EPA-AA-TEB-511-83-7

EPA Evaluation of the POWERFUEL Extender System Under
Section 511 of the Motor Vehicle Information
and Cost Savings Act

August 1983

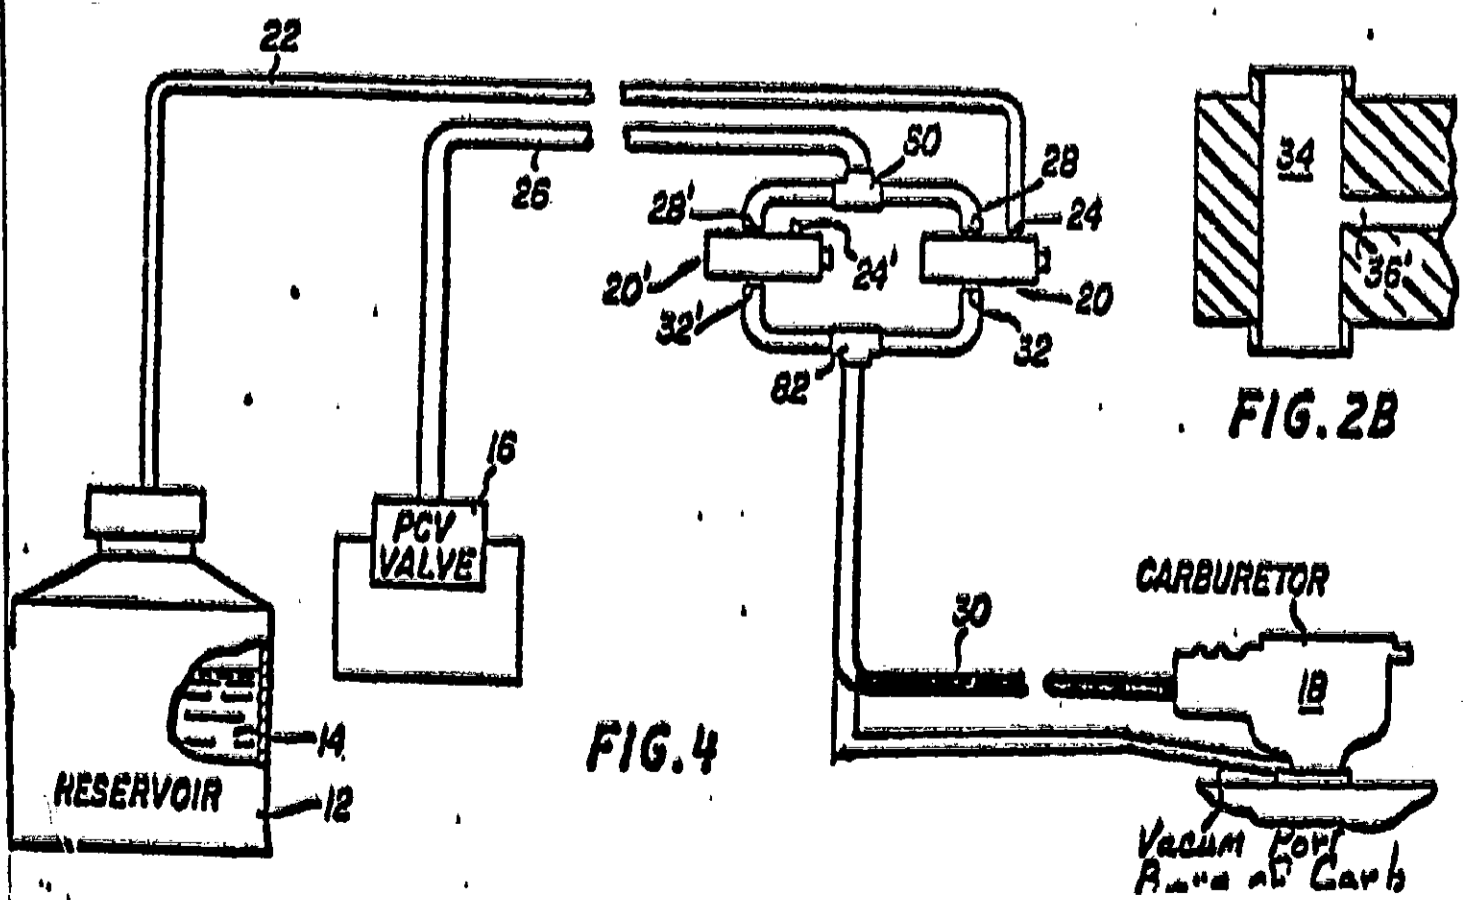
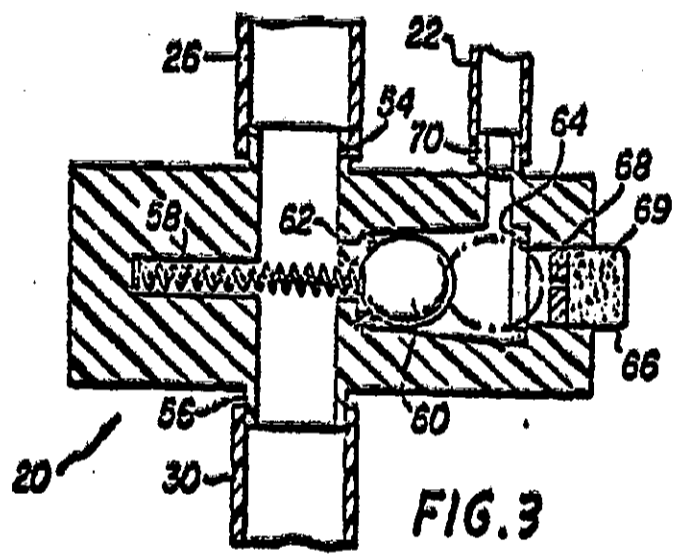
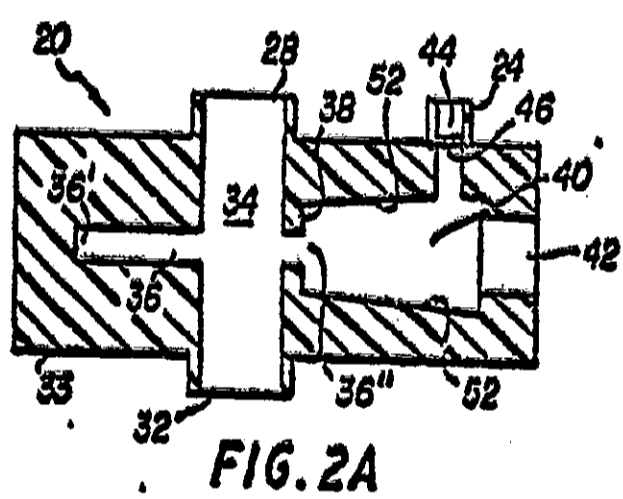
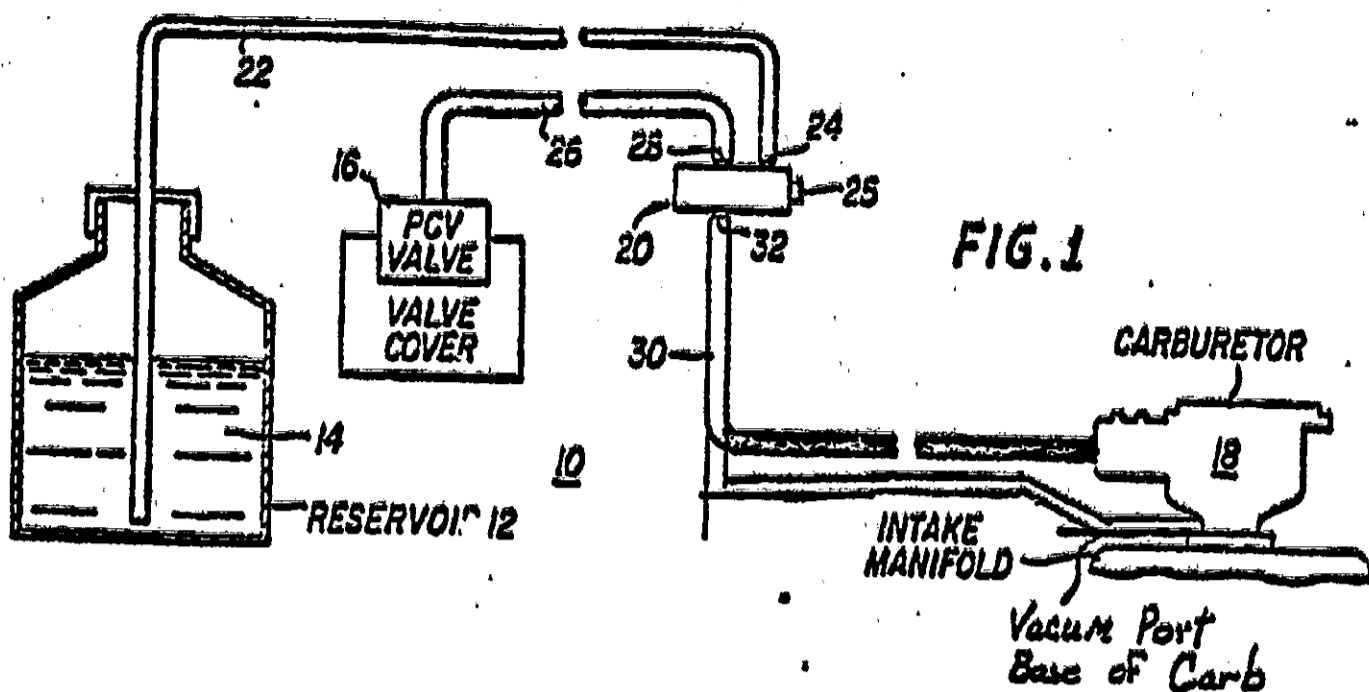
There are two areas of the patent application (Attachment A) which were not clarified. First, Figure 2A shows a flow restrictor (item 46) which differs in design from that depicted in the installation instructions (Attachments C and D). Second, Figures 1 and 4 show that two different installation configurations are possible.

5. The patent application shows the vacuum valve flow restrictor hole as being different in design from that depicted in the installation instruction sheet. Does this mean the application for evaluation applies to more than one design? Are different models available?

6. Does your application for evaluation also apply to the two-valve configuration shown in Figure 4 of your patent application?

9. Where will replacement POWERFUEL fluid be purchased and at what price?
10. Based on our understanding of the device, there are three possible positions for the vacuum valve checkball (item 60 in Figure 3 of patent application) as follows:

Is our understanding correct? If so, then it would seem that even if the POWERFUEL fluid were depleted, there would still be air bleeding in positions b and c. Thus, this would be contrary to your statement that the engine returns to its previous condition (before device installation). Please clarify or confirm our understanding.

EPA asked the applicant whether his application applied to more than one design and installation configuration (Attachment E). The applicant responded (Attachment F) that only one design is currently available. He also stated the application applied only to the single valve installation configuration shown in Figure 1 of the patent application.

10. Your understanding of the "O" ring-checkball arrangement is correct, furthermore, if the fluid is depleted, air would leak in through positions b and c. However, the maximum orifice size is 0.090" dia. (preferred 0.041) which results in an orifice cross sectional area of 0.006362 inch square as compared to the carburetor throat opening of 2" or a cross flow sectional area of 3.1416 inch square. Since both orifices are at the same pressure during acceleration, the flowrates are proportional to the cross flow areas. In this case an area ratio of about 500 (493.8) to 1 exists which means that in the case of depleted fluid, the flowrate of air through the valve is about 0.2% of the carburetor flowrate. This amount is less than the design precision of the engine air intake system. Furthermore, a dirty air filter would decrease air flow by much more than 0.2%. Thus the statement that the device would return the engine upon fluid depletion to pre-device installation conditions is still valid. Remember that the valve operates only if the vacuum falls below the 3" needed to switch it on. This condition occurs only during hard acceleration or a small portion of the time that the engine operates.

INSTRUCTIONS

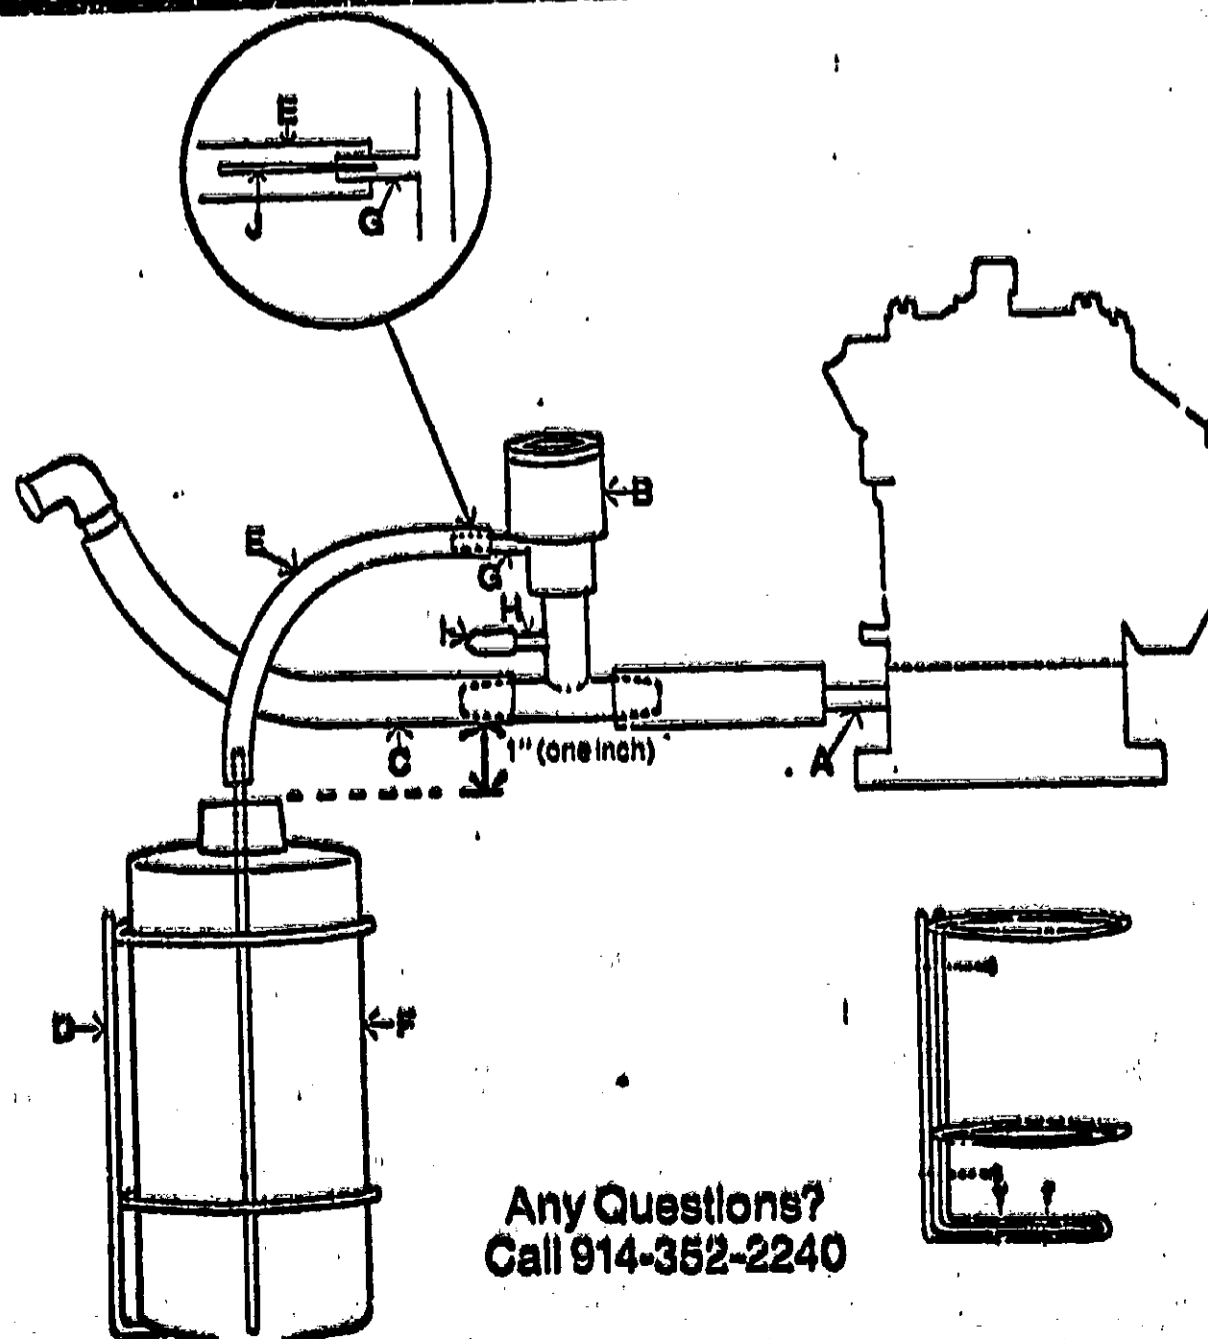
7. Your application states that no tools are needed for device installation. Yet, the installation instructions attached to your letter of August 10 indicate that at least a knife, screwdriver, and drill are required. Please clarify this apparent discrepancy.
